ADDENDUM NO. 1

PROJECT: Sam Collins Park Phase 1B

BID NO.: RFB 25-1203

FROM: Kristina Malek
Project Manager – Landscape Architecture
Kimley-Horn
11700 Katy Fwy, Suite 800
Houston, Texas 77079

SHEET NUMBER
G0.02

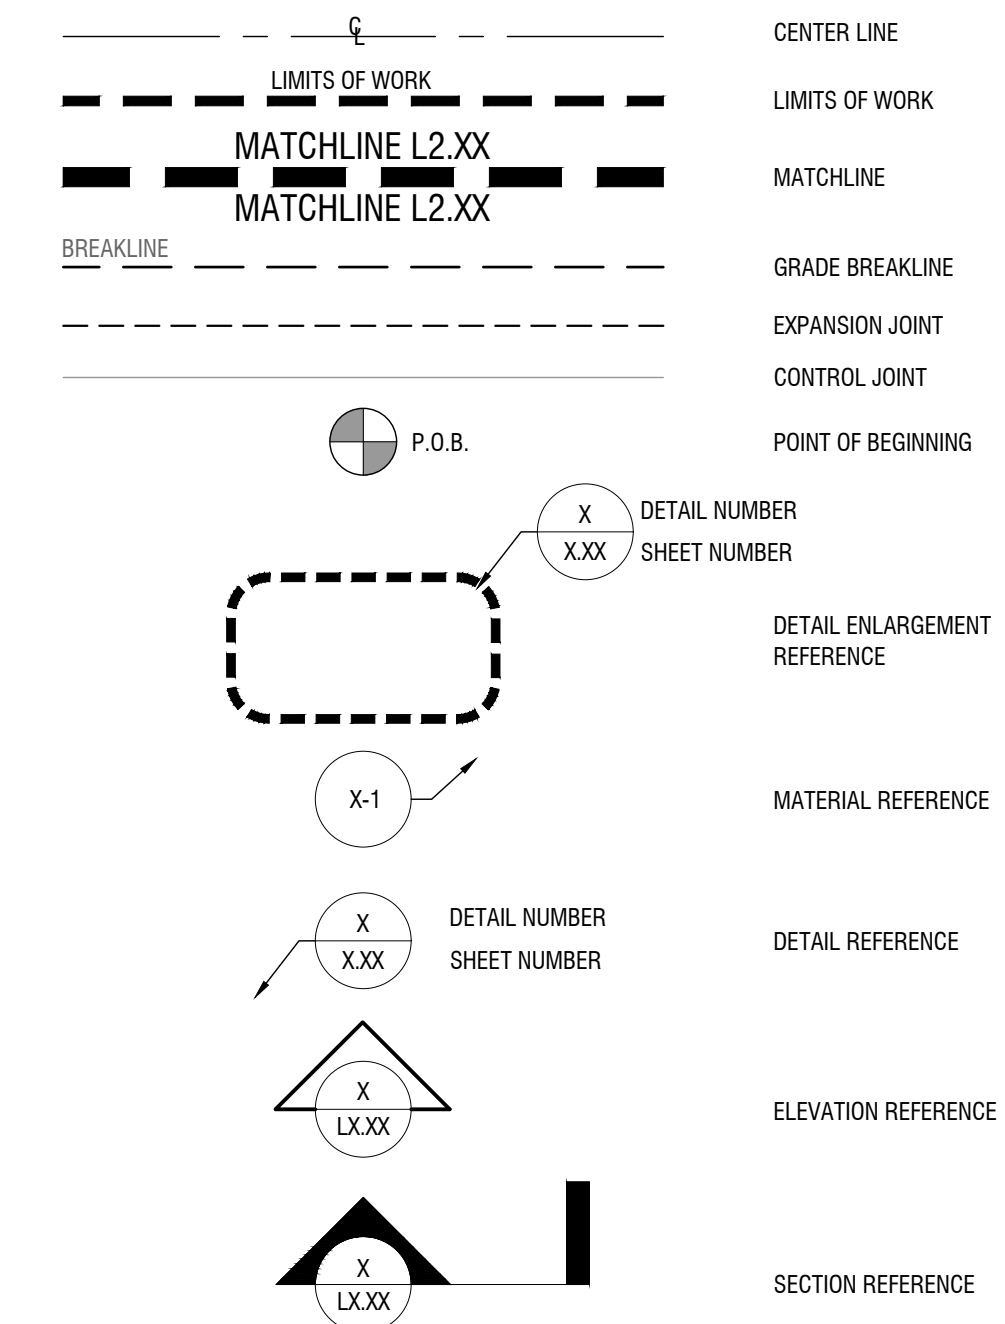
1. Question: Contact information for CXT and serial number/build number?
Response: The building I.D. number is N0541182955
2. Question: Will the underside of the pavilion tongue and groove decking require staining?
Response: Yes, provide staining. Color to be selected by owner. See Sheet L3.03 and G0.02.
3. Question: Replace R-panel roof?
Response: Yes, replace metal R-panel roof ensure color to match existing. See Sheet L3.03 and G0.02.
4. Question: Would you please confirm if the pre-bid conference is at 1 PM or 2 PM on August 20th?
Response: 2pm CST
5. Question: Add unit item at pavilion rehab for “Re-coating steel members” to the plans, SOW, and bid proposal sheet

6. Question: Pavilion – specify the 1” x 6” tongue and groove panels

8. Question: Note Kraftsmen and Playwell are approved manufacturers for the playground equipment.

9. Question: Once removed, the picnic tables shall be stored on site for Owner’s use (do not re-install)

Response: Re-coating steel members added on sheet G0.02 and L3.03

Response: Note revised to include 1” x 6” on sheet G0.02 and L3.03

Response: Note added on sheet G0.02

Response: Note added on sheet L3.03 and G0.02.

SHEET NUMBER
L1.00

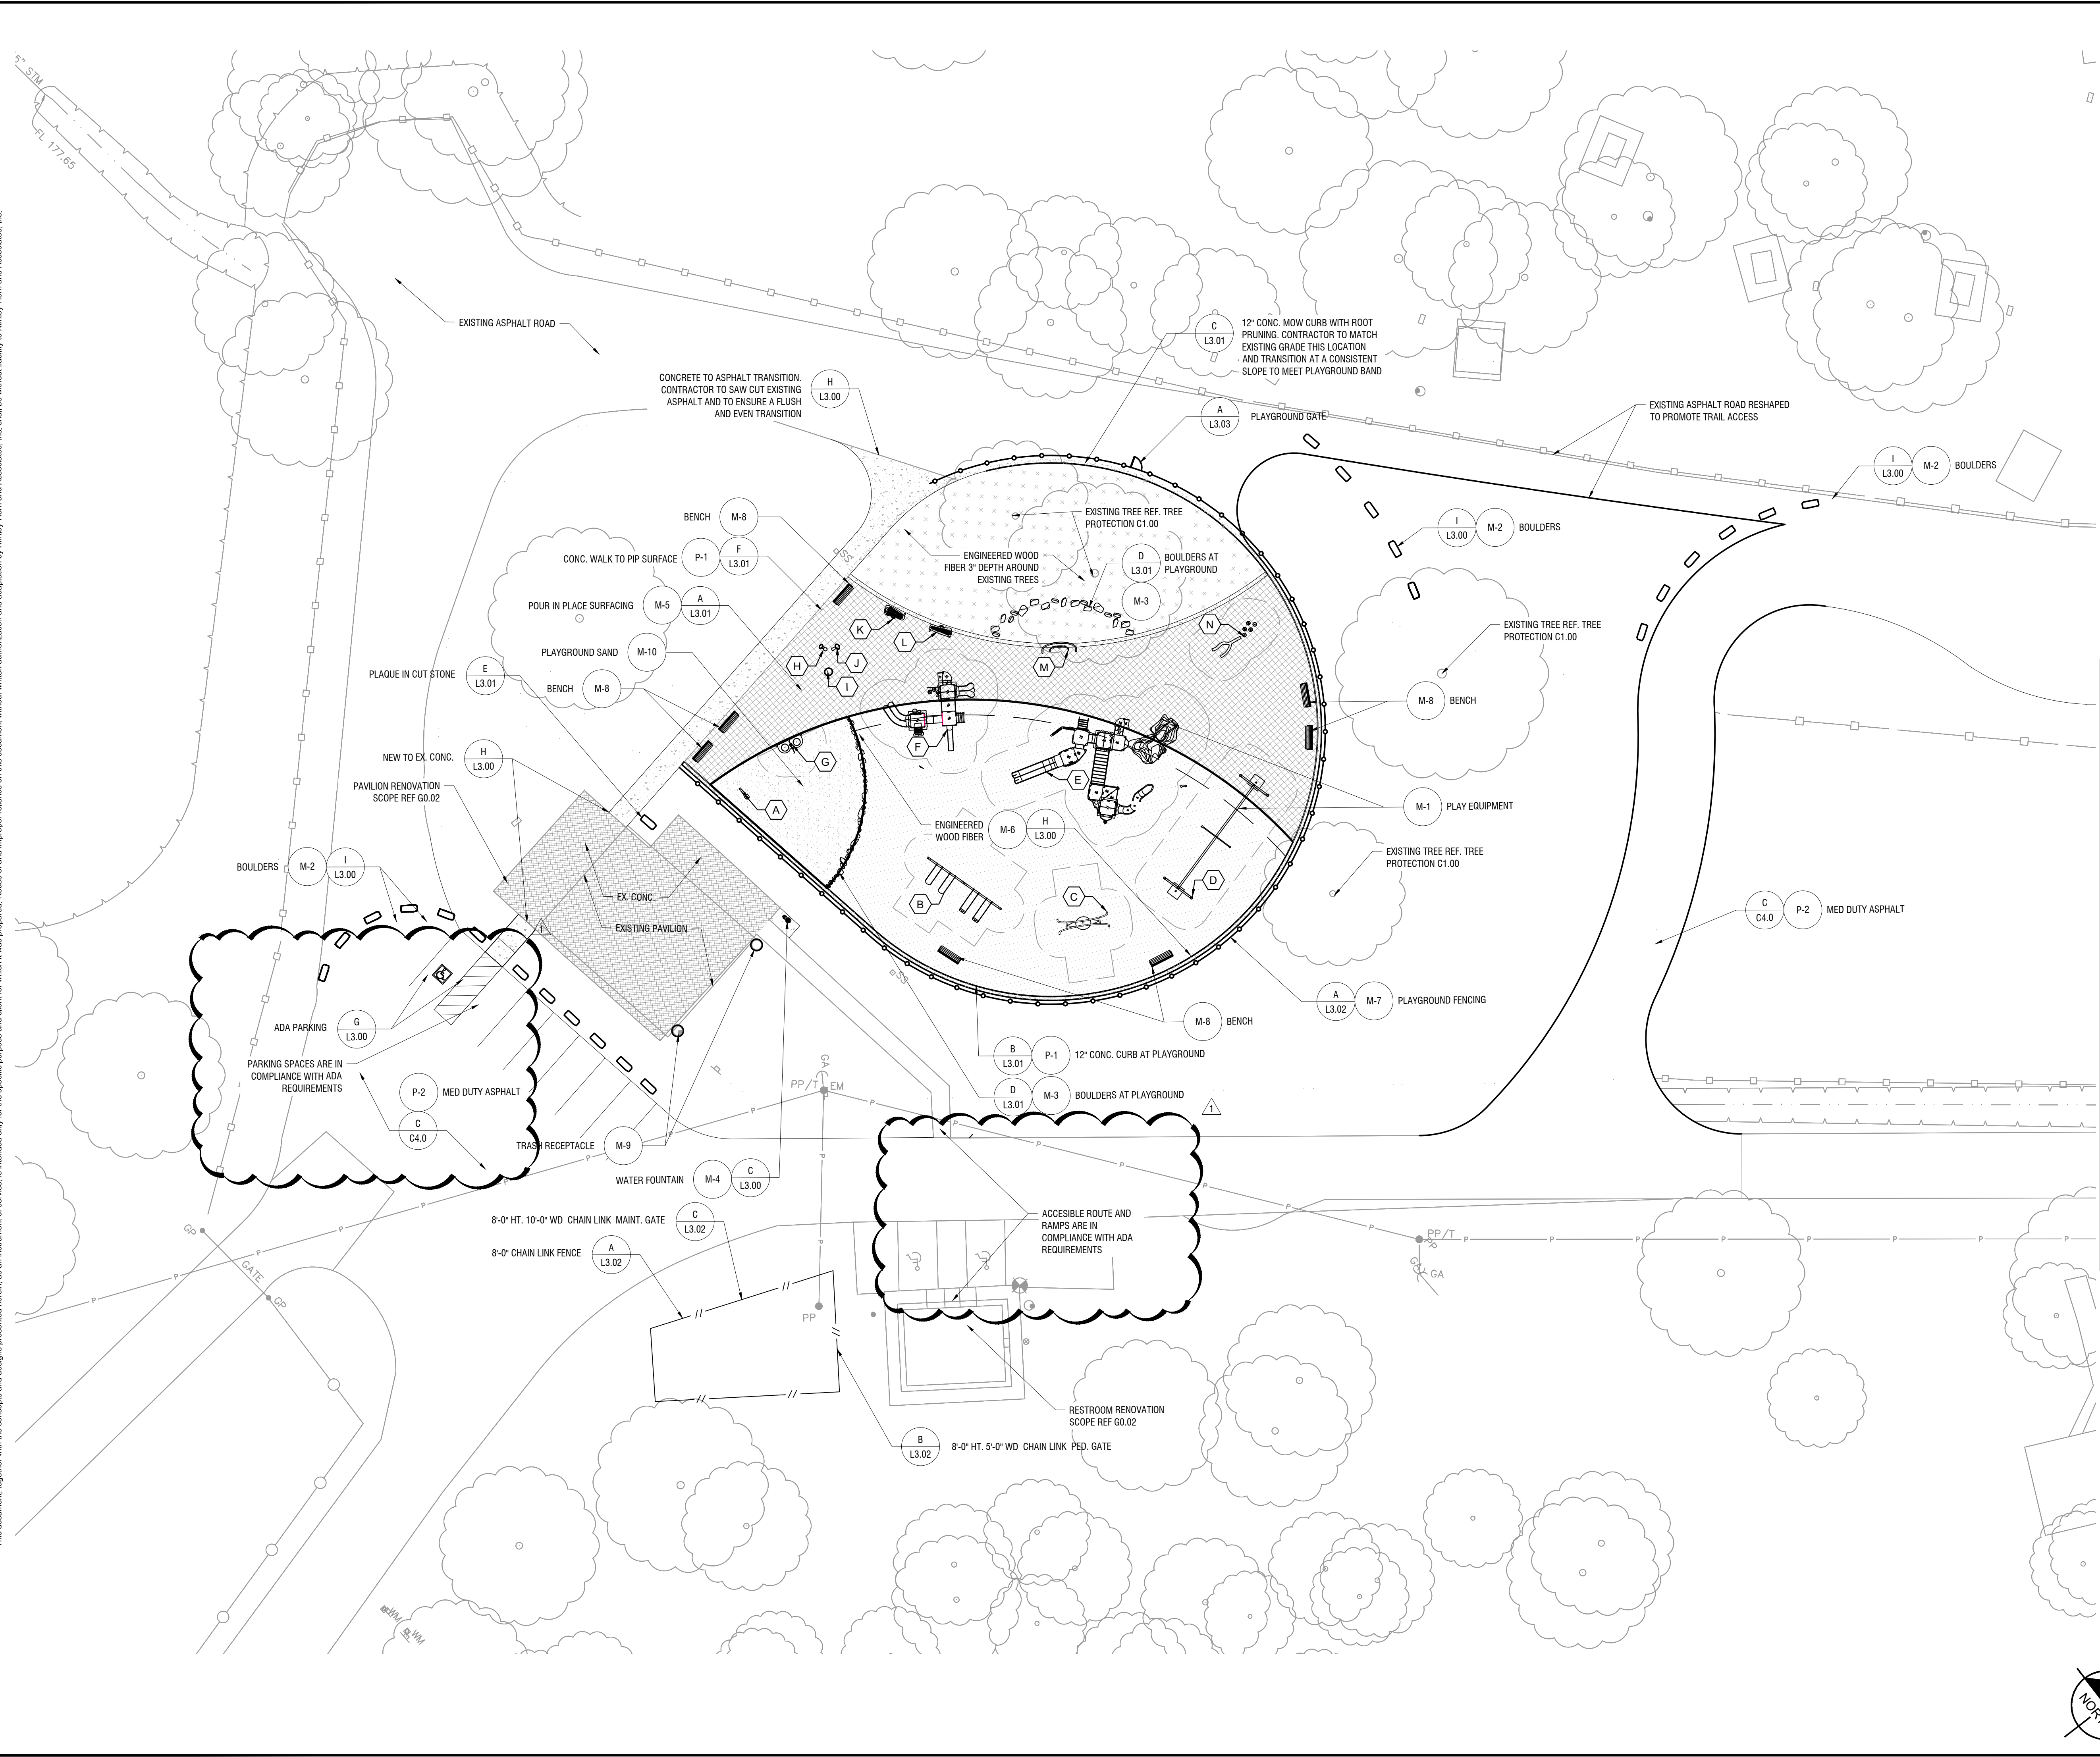
1. RAS report updates.
 - Ramps – Note was added to Sheet L1.00 that ramps are ADA compliant.
 - Parking Spaces – Note was added to Sheet L1.00 that parking spaces are compliant. ADA van parking space added to plans.
 - Playground – Note added to Sheet G0.02 that playground vendor responsible for verifying play equipment compliance.
 - Water Fountains – Note added to Sheet L3.03 that new water fountains to comply with ADA requirements.
 - Plumbing – Note added to Sheet L3.03 that the new plumbing fixtures should comply with ADA requirements.
 - Bathroom Doorways – Note added on Sheet G0.02 and L3.03 that door hardware should be switched to other side of the doors to comply with ADA ramp requirement.

- Accessible Route – Note added on Sheet L1.00 that accessible route to restroom and ramps are compliant.
- 2. Tongue and Groove decking staining note added to viewport ‘A’ and pavilion notes on L3.03 and G0.02
- 3. Replace and Relocate Restroom door hardware note to comply with ADA added to viewport ‘B’ and restroom notes on L3.03 and G0.02
- 4. Note added on sheet L3.03 and G0.02 to replace R-panel roof and ensure color to match existing.
- 5. Note to Re-coat steel members added to sheet G0.02 and L3.03.
- 6. Note to specify 1”x6” tongue and groove panels added to sheet G0.02 and L3.03.
- 7. Note about playground equipment approved manufacturers added on sheet G0.02.
- 8. Note about picnic tables being stored on site for Owner’s use added on G0.02 and L3.03.
- 9. Note about pea gravel being stored on site for Owner’s use added on C1.00.

SHEET NUMBER
C1.00

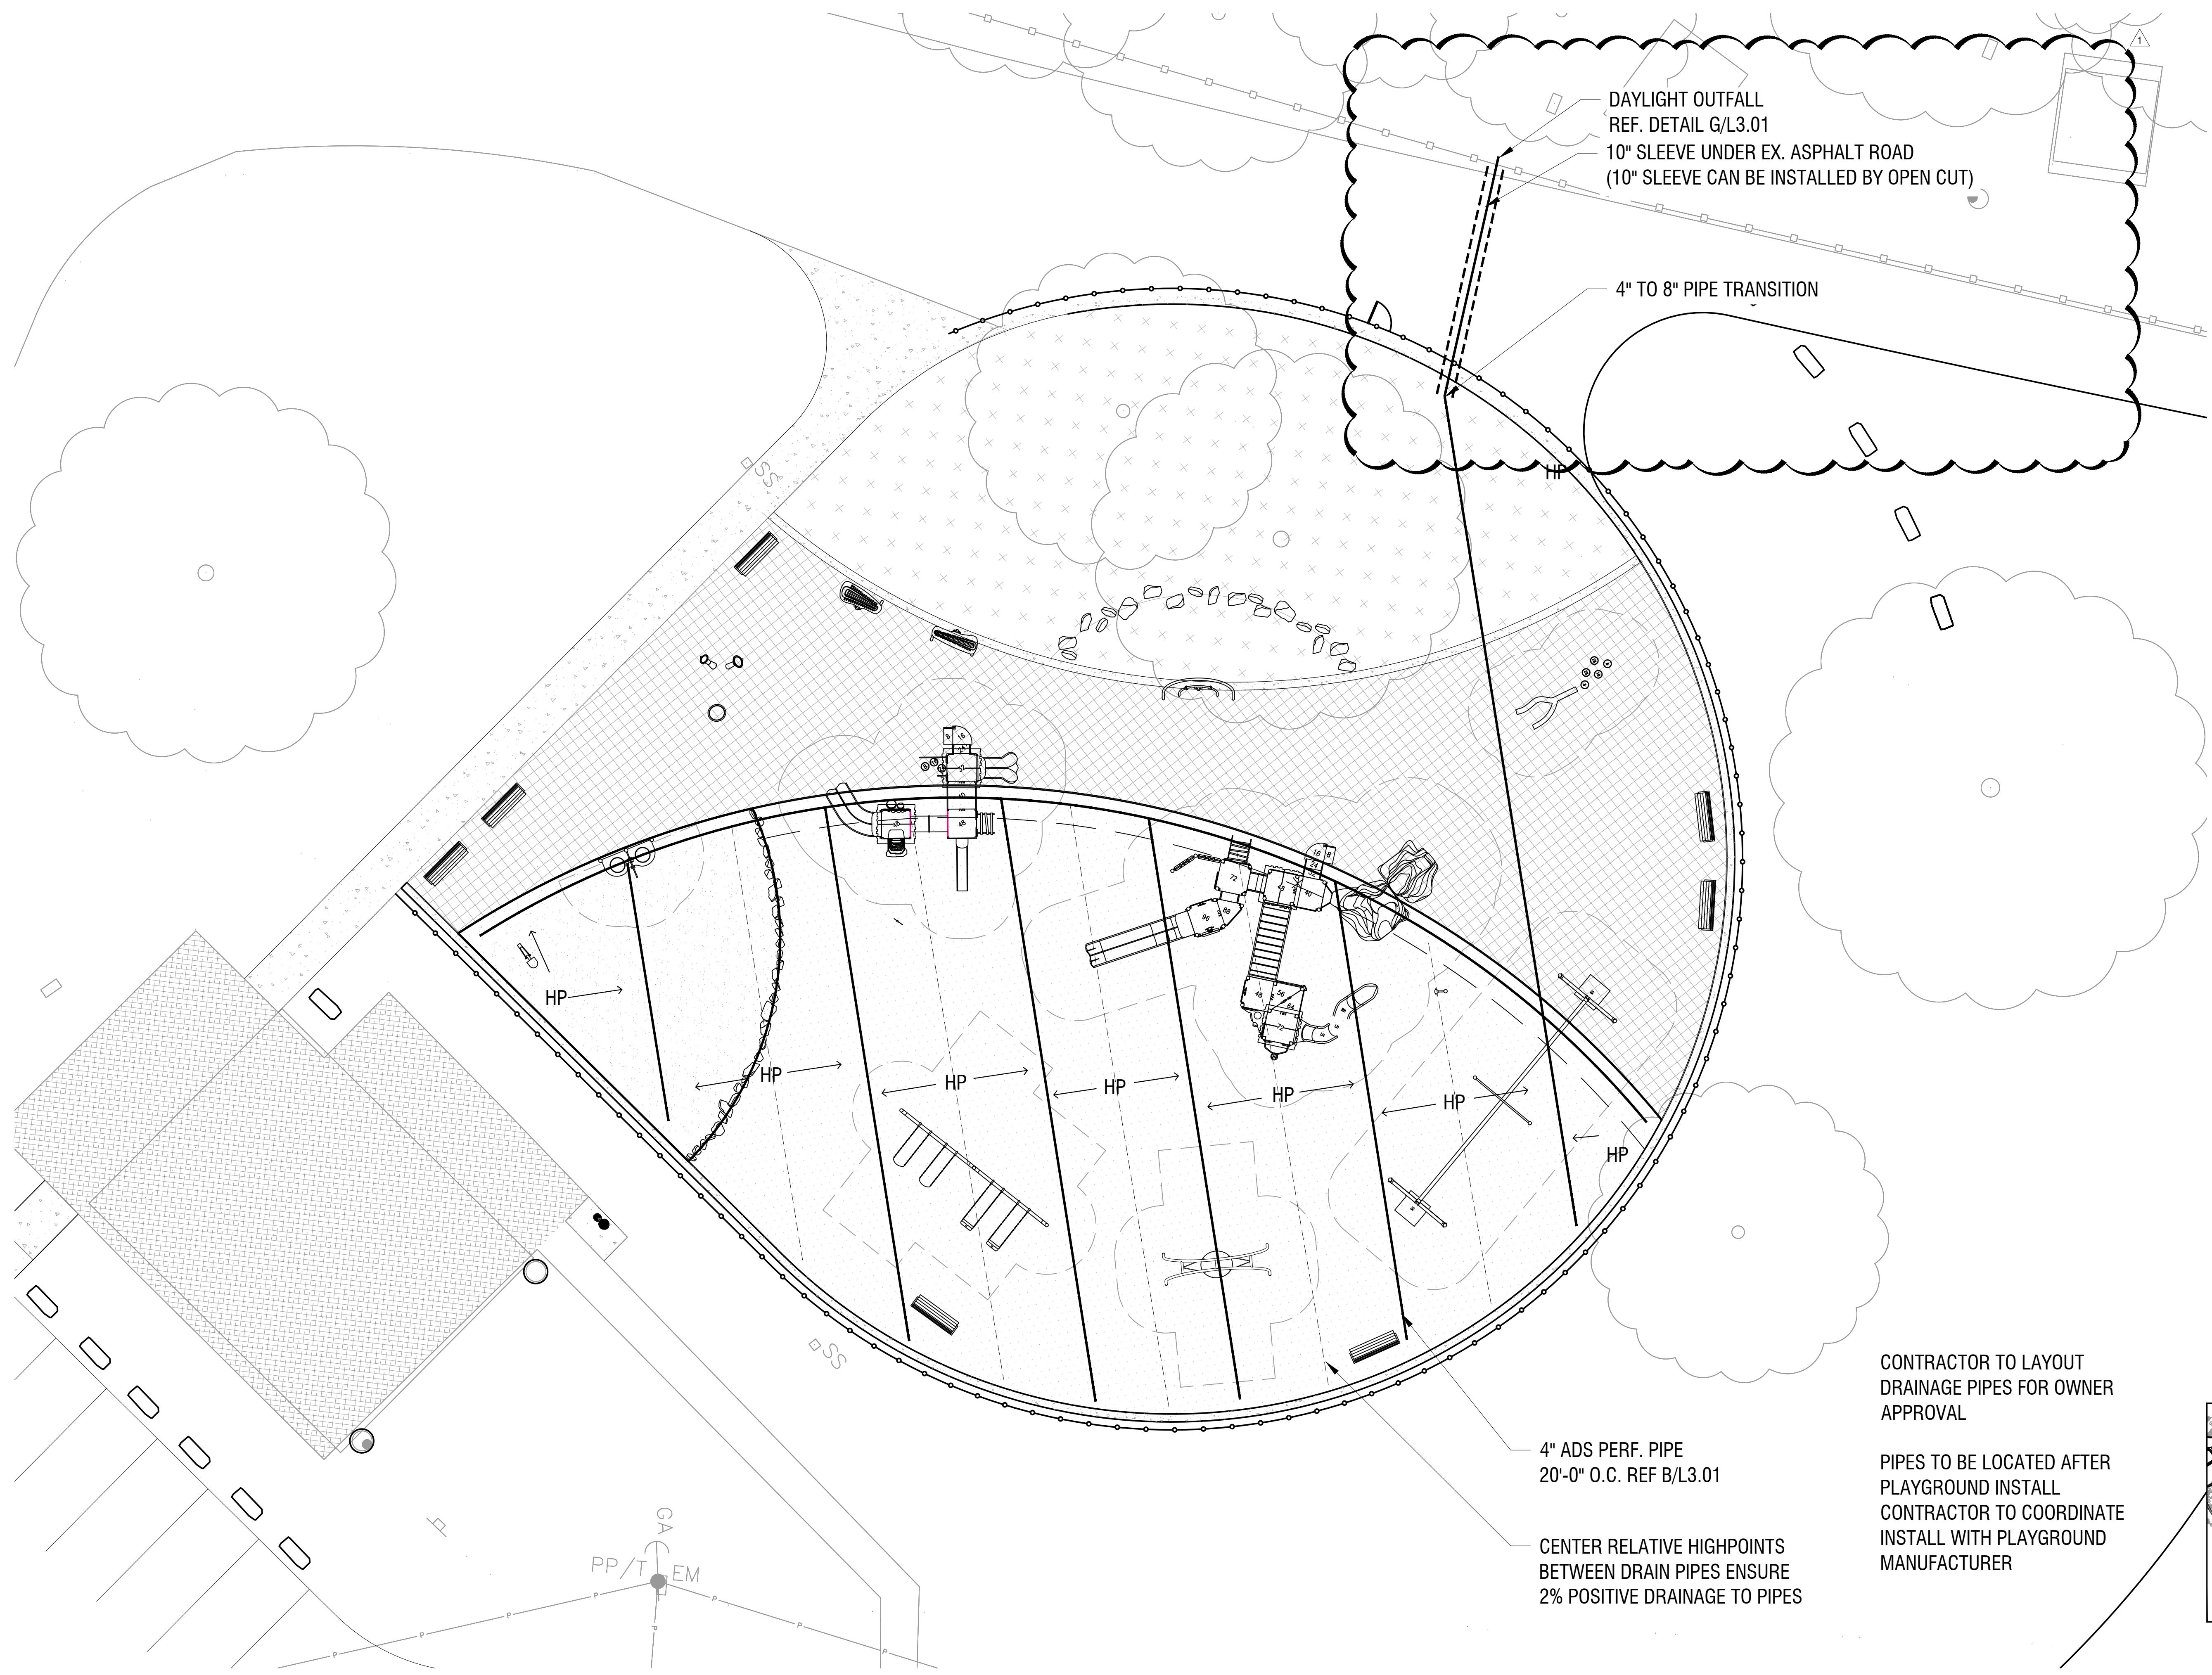
10. Question: Once removed, the pea gravel on the existing playground shall be stored on site for Owner’s use.

Response: Note added on sheet C1.00.

SHEET NUMBER
L2.01

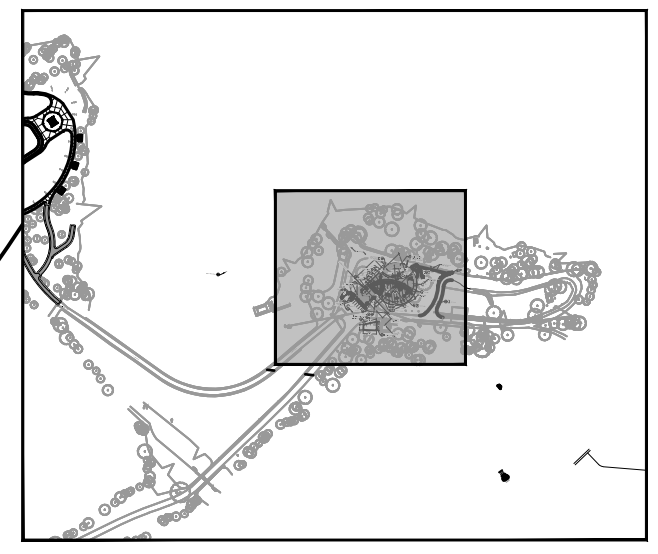
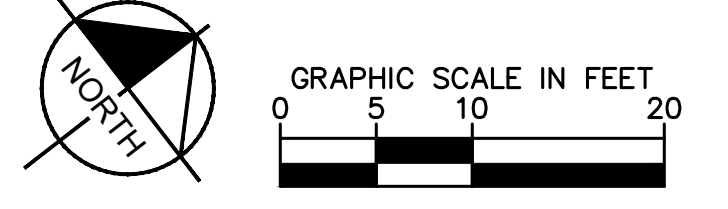
7. Question: Note that the 10” sleeve for daylight drain can be installed by open cut.

Response: Note added on sheet L2.01
